Special Bulletin

SP16-300B

CAC TUBE HANGER REPLACEMENT

Prevost vehicles

Figure 1

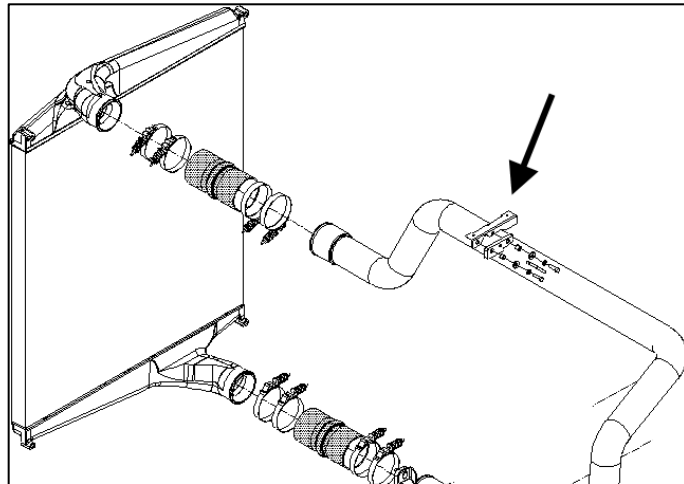
1. Locate this support (arrow, fig. 1) along the top charge air cooler line in the engine compartment.

Figure 2

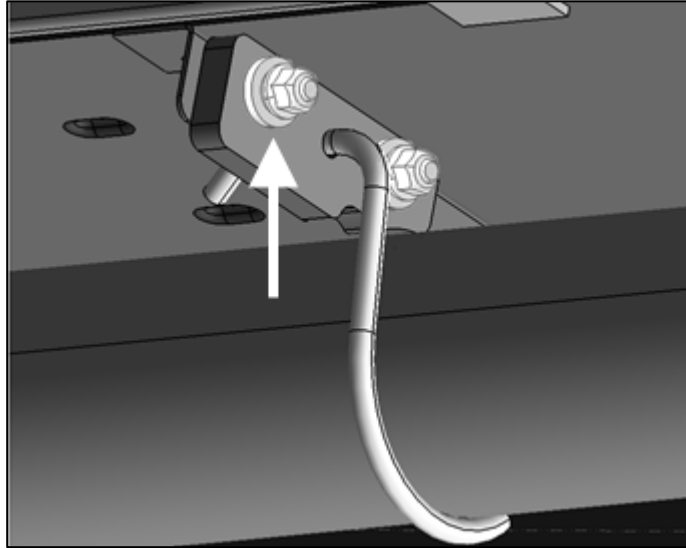
2. Remove the outer nut and washer. Discard hardware.

Figure 3

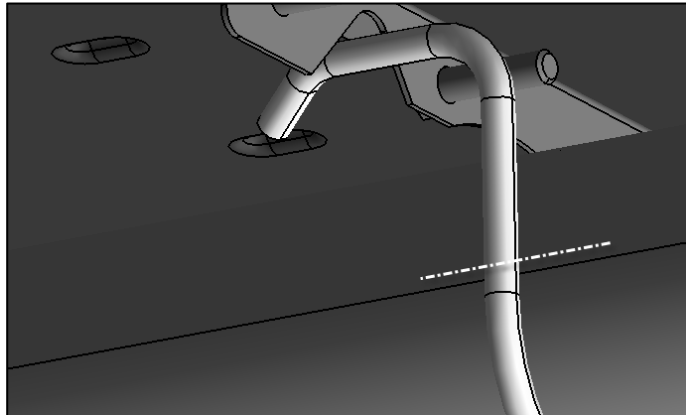
3. Cut the support rod at indicated location in Figure 4

Be careful not to cut into the CAC pipe. Remove sharp edges on the support rod with a file.

Figure 4

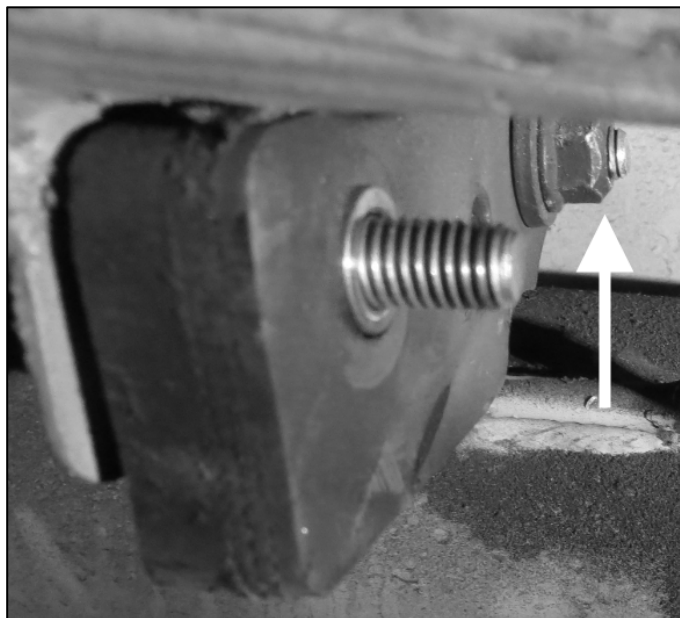
4. Remove the inner nut, washer and rubber damper. Discard hardware.

Figure 5

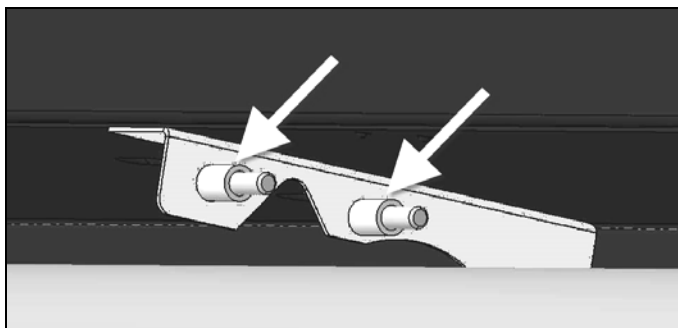
5. Discard the old sleeves.

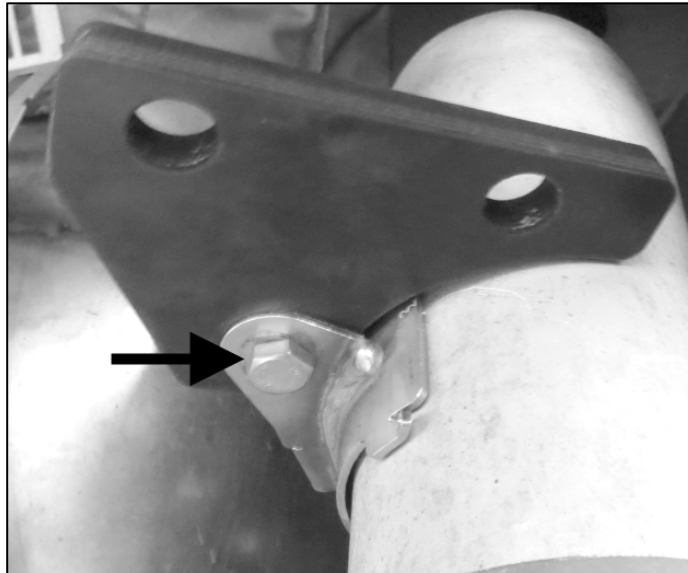
6. Install sleeve **#032540** in the lower hole of the new rubber damper **#050009**.
7. Assemble in saddle **#050012** with screw **#5001499**, nut **#502837**. Do not tighten yet.

Align saddle and rubber damper on an easily accessible section of CAC pipe.

Proceed to final tightening while holding parts.

Torque to **16lbf-ft**

Check alignment after tightening.

Figure 6

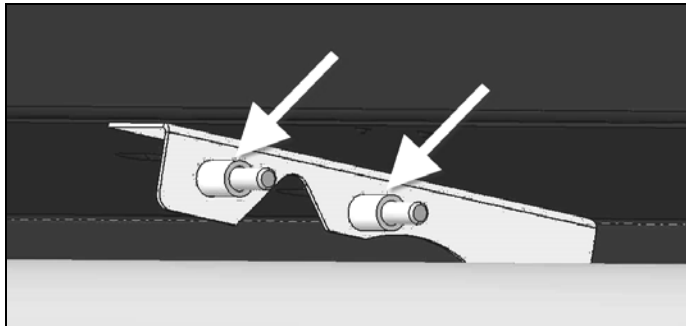
8. Install two new sleeves **#032540** on existing bracket studs.

Figure 7

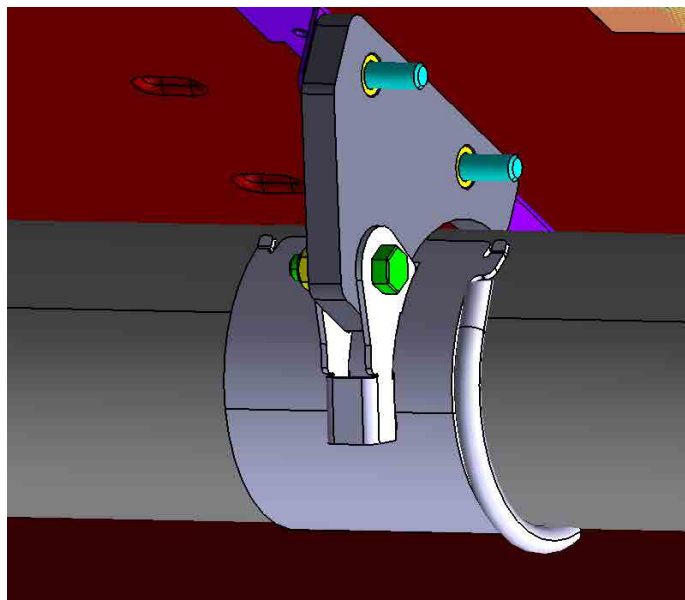
9. Slide assembled saddle and damper in place on CAC pipe and bracket.

Figure 8

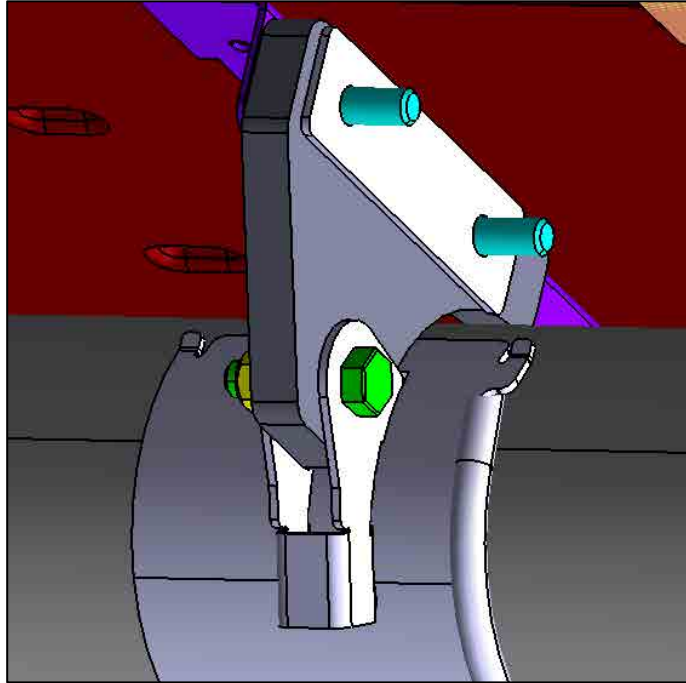
10. Place plate #053026 over the support studs.

Figure 9

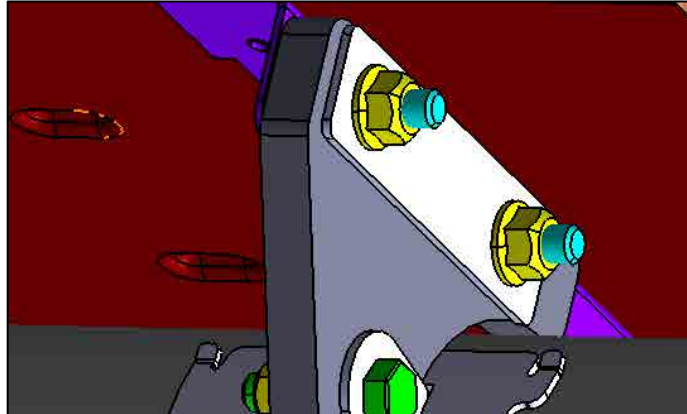
11. Install nuts #502837.

Tighten to **16 lb-ft.**

Add torque seal mark to all bolts.

Figure 10

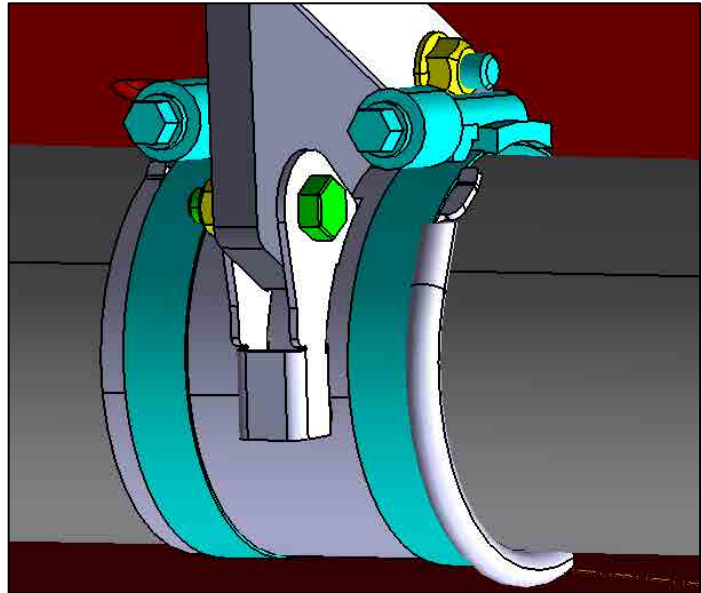
- Install the two tube clamps #504580 as shown. Collar drive screw should be horizontal to allow easy access.

Tighten to **8 lb-ft.**

Add torque seal mark to both clamps.
